W3F1-2010-0050

**Subject:** Response to Request for Additional Information Associated with  
Technical Specification Table 3.4-1 Isolation Valve Addition  
Waterford Steam Electric Station Unit 3  
Docket No. 50-382  
License No. NPF-38

**Response to Request for Additional Information**

B424  
 SHEET E591

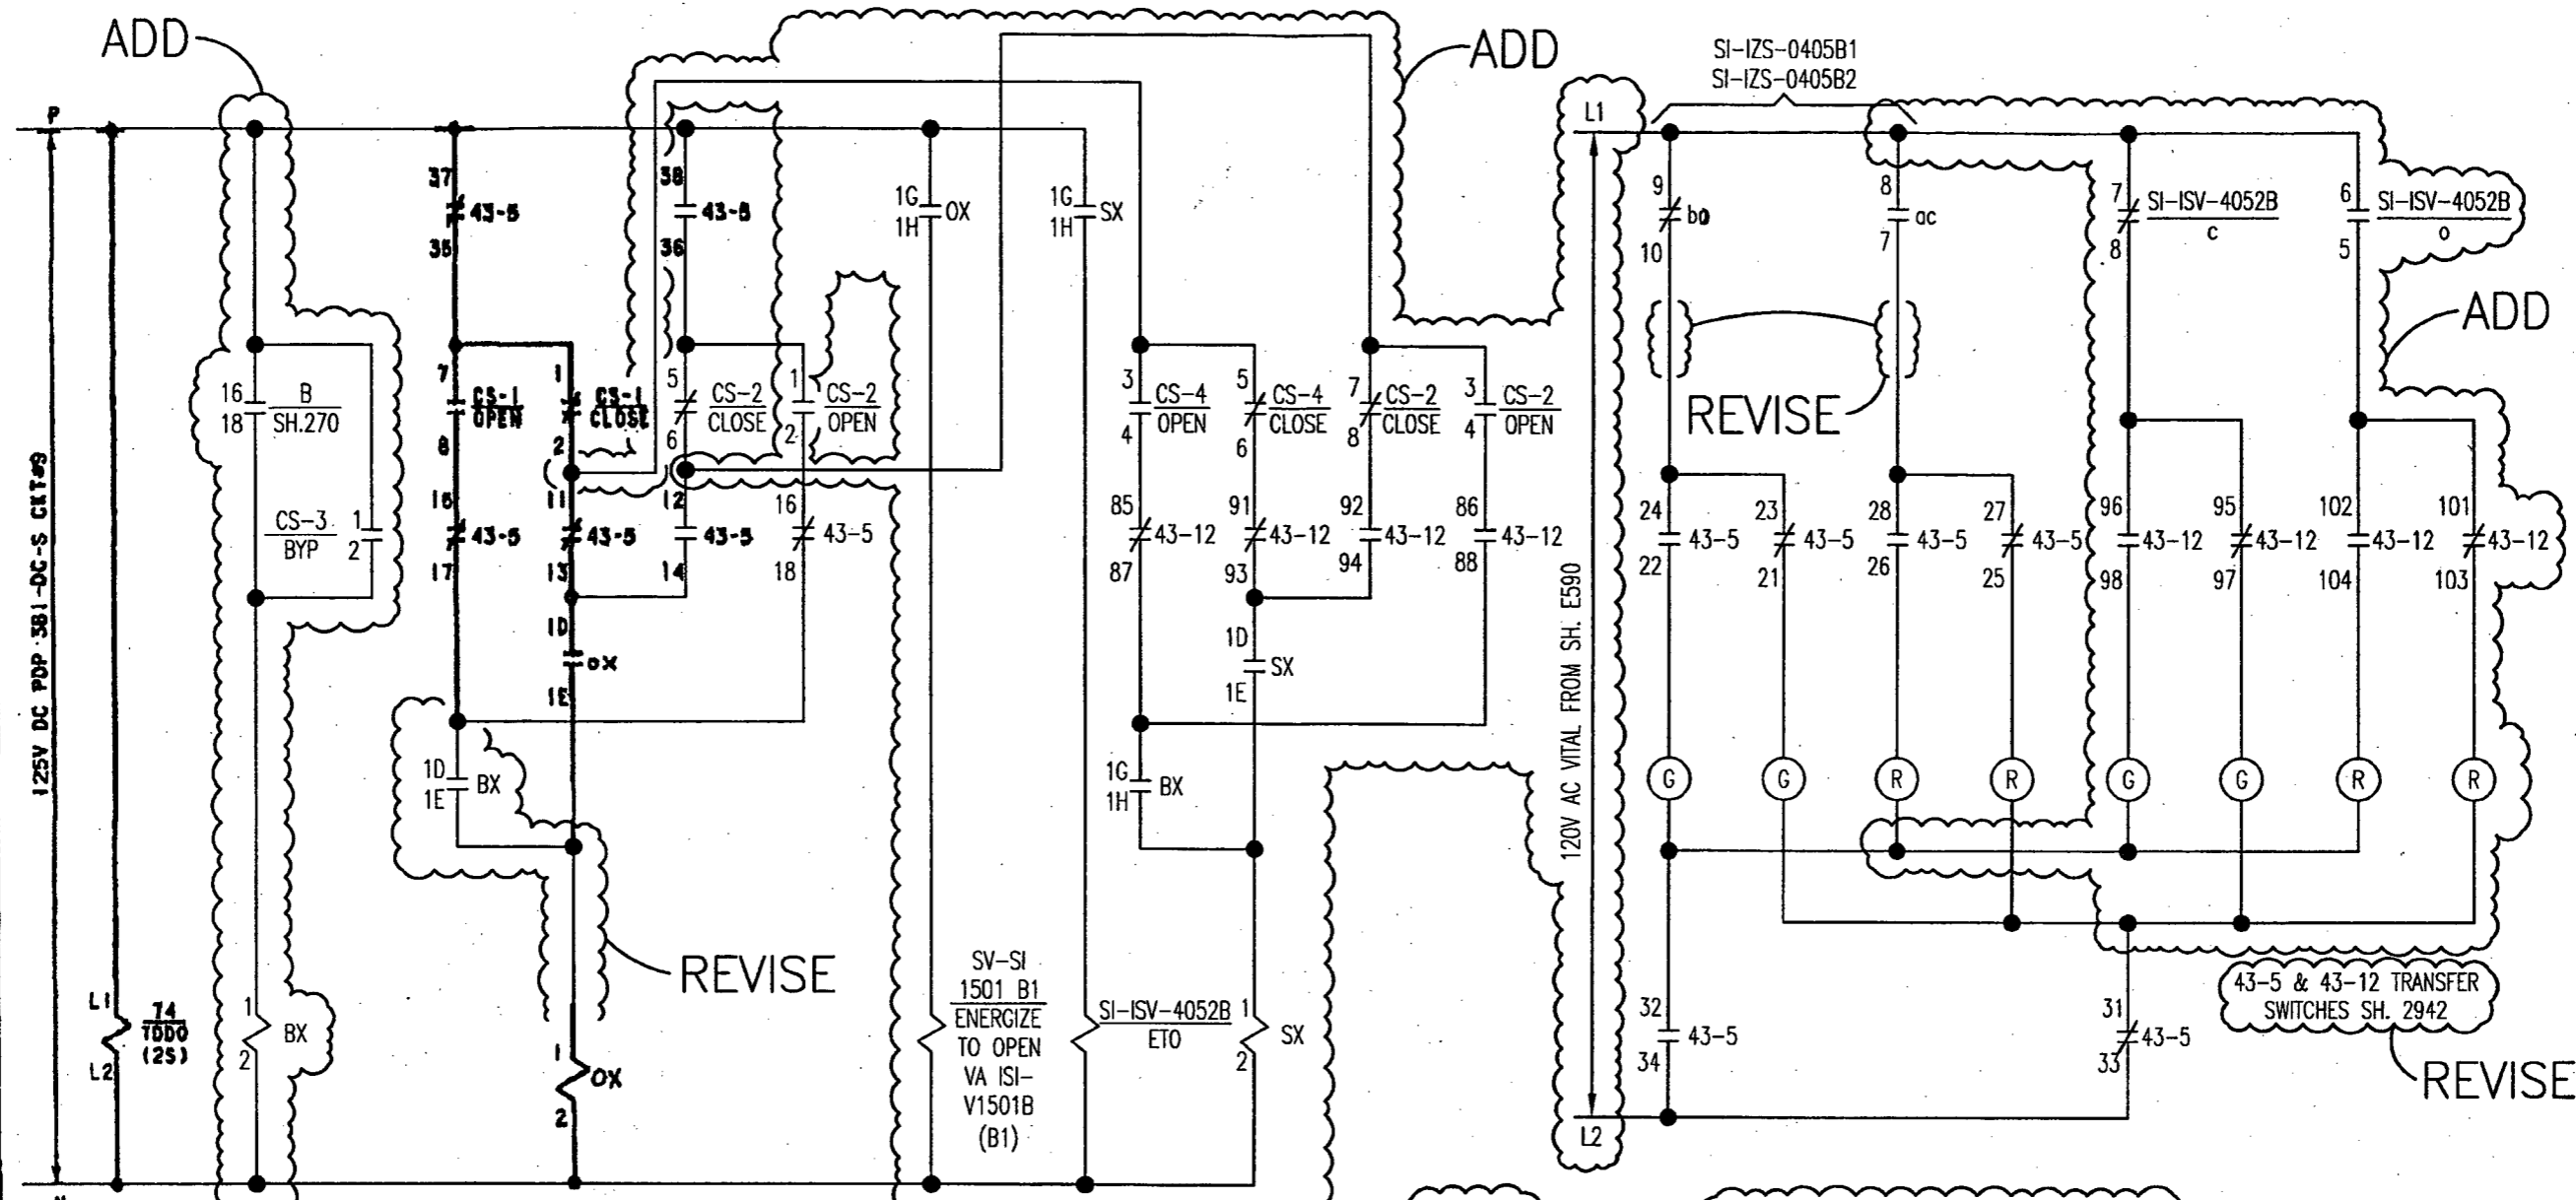
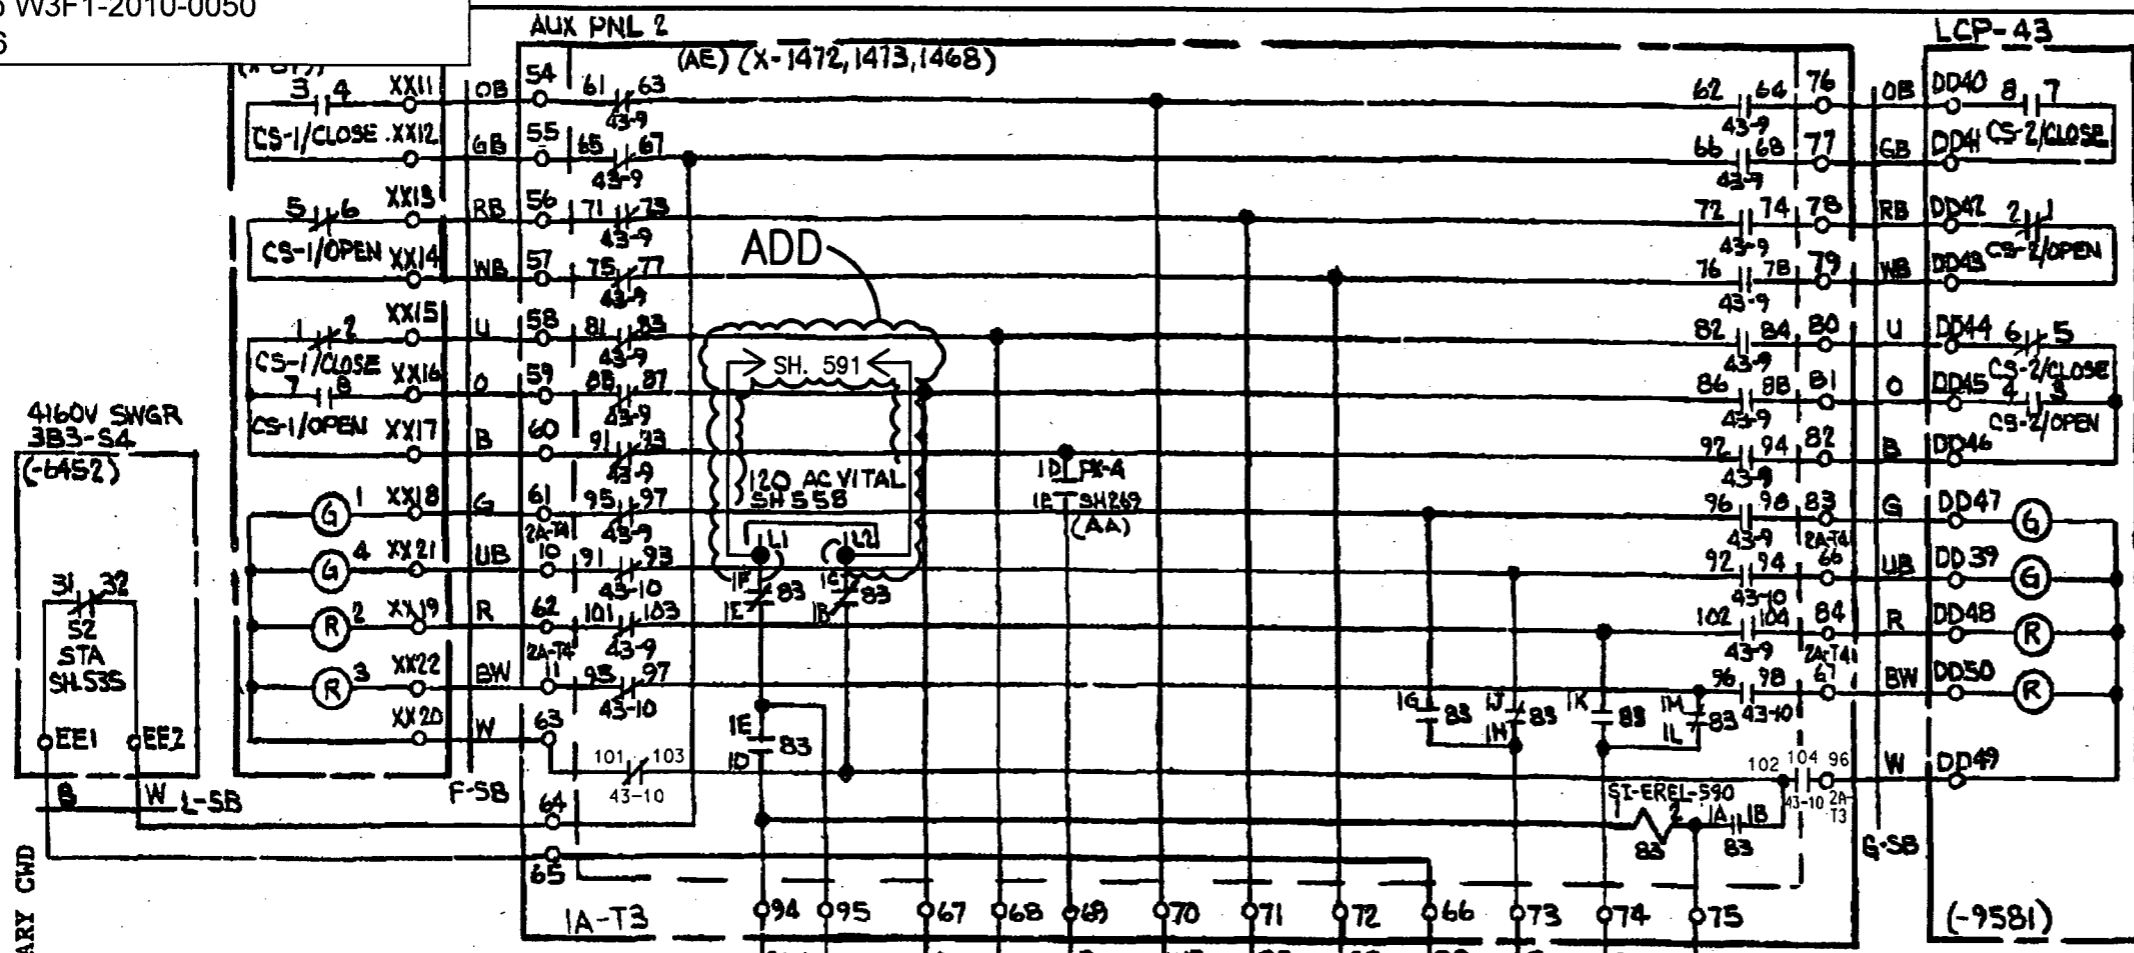
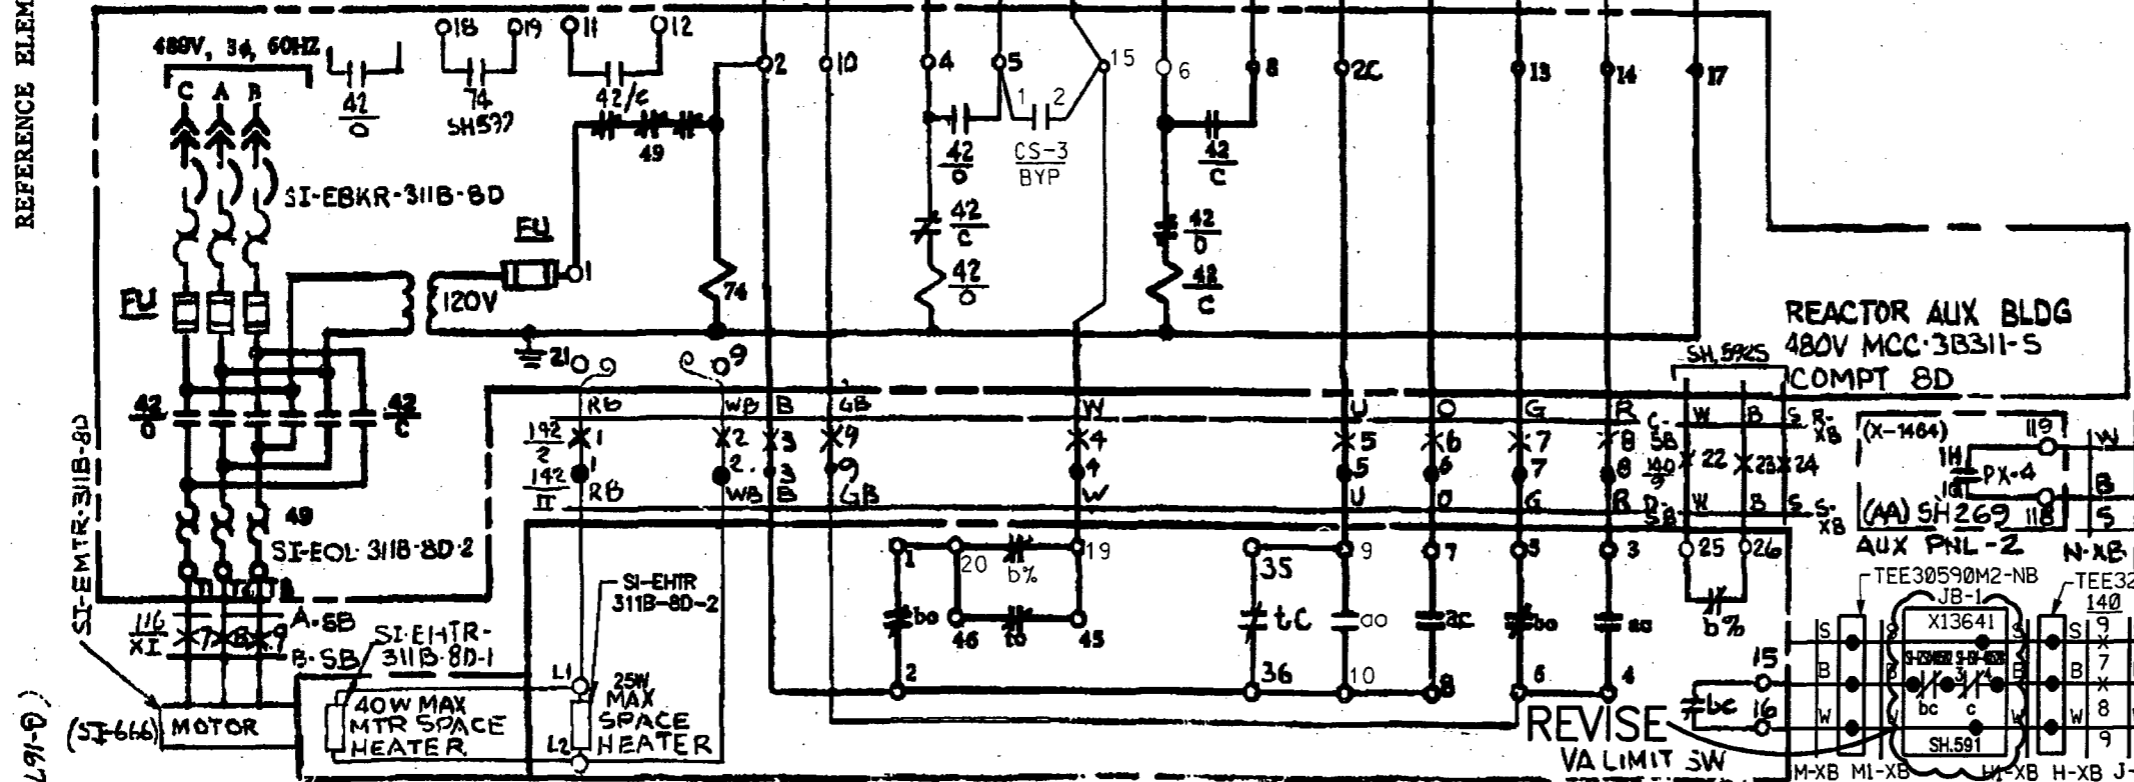
Provide the electrical one line and applicable schematic drawings showing the power and control circuits for valves SI-4052A and SI-4052B.

Drawings B424 Sheets 591, E591, 590, and E590 are the schematic drawings showing the power for valve SI-4052B and its indication lights.
